Dear City Council & Staff,

Redondo Beach Parking Reform

REAR PARKING LOTS

LIMIT DRIVEWAY CURB CUTS

Lavendar & Honey– with 3 businesses. No driveways/parking allows 2 more businesses as infill development.

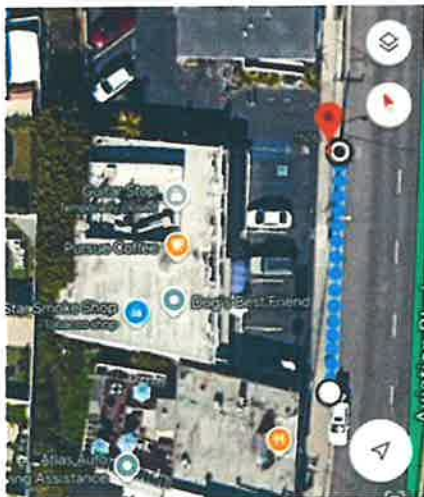
202' block currently 3 on street parking spaces & 8 off street parking spaces

Parallel Parking – 10 parking spaces (5/100') if no driveways

Angled Parking – 16 parking spaces (8/100') if no driveways

EXISTING ONE WAY DRIVEWAYS: (Aviation Blvd)
More street frontage, better pedestrian experience

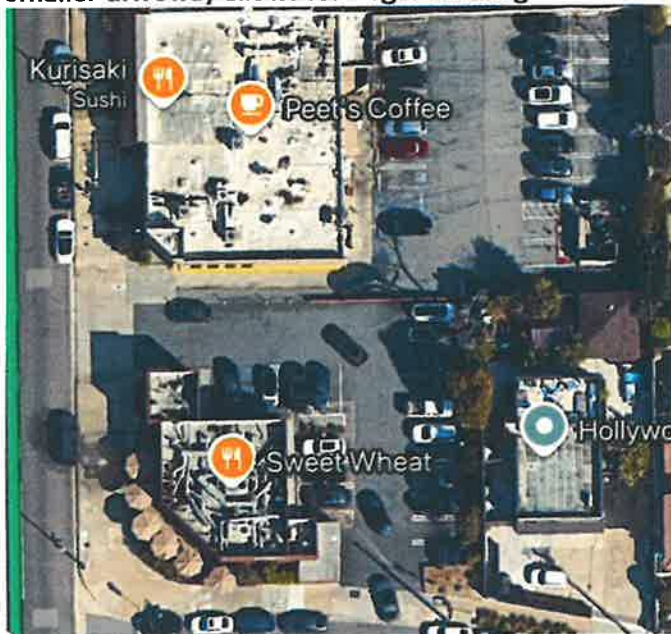
11' Driveway to Rear Parking Lot

10'6" Driveway to Rear Parking Lot
